Sub: REVIEW OF L – ZONE PLAN UNDER MPD - 2021

L-Zonal Plan & Neighboring Areas — Suggestions for Review

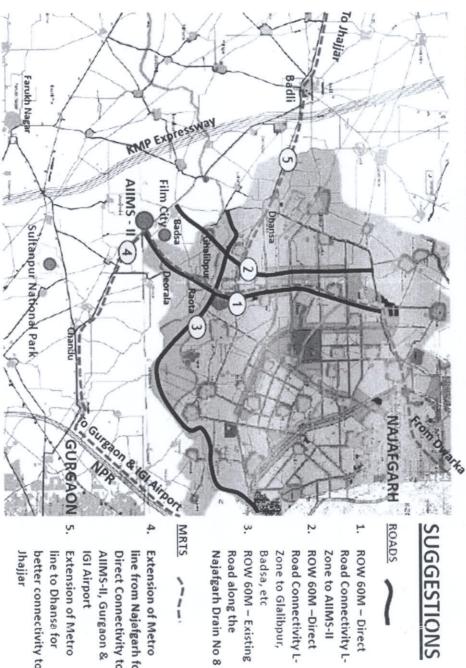
In this light, it is suggested that a minimum 60m ROW be kept for the aforementioned 2 (two) roads so as to provide good road access to the institutional area as the second phase of AIIMS will cater to the needs of the whole of the L Zone area. (See suggestion in Map as Annexure)

It is suggested that this existing road be improved and proposed in the Zonal Plan with a minimum 60m ROW. (See suggestion in Map as Annexure)

- It may be reiterated that MRTS should be planned upto the border, along the aforementioned roads and the MRTS should get connected to the AIIMS-II and thereon to Gurgaon (See suggestion in Map as Annexure)
- It is understood that there is a proposal to extend the existing metro line upto Najafgarh.
 This same line should get extended upto Dhansa via the 60m ROW road and extend to Badli and Jhajjar on the Haryana side. (See suggestion in Map as Annexure)

- Zone to AIIMS-II Road Connectivity L-ROW 60M - Direct
- ROW 60M Existing Zone to Glalibpur, Road Connectivity L-
- **Direct Connectivity to** Extension of Metro AIIMS-II, Gurgaon & line from Najafgarh for
- Extension of Metro better connectivity to line to Dhansa for
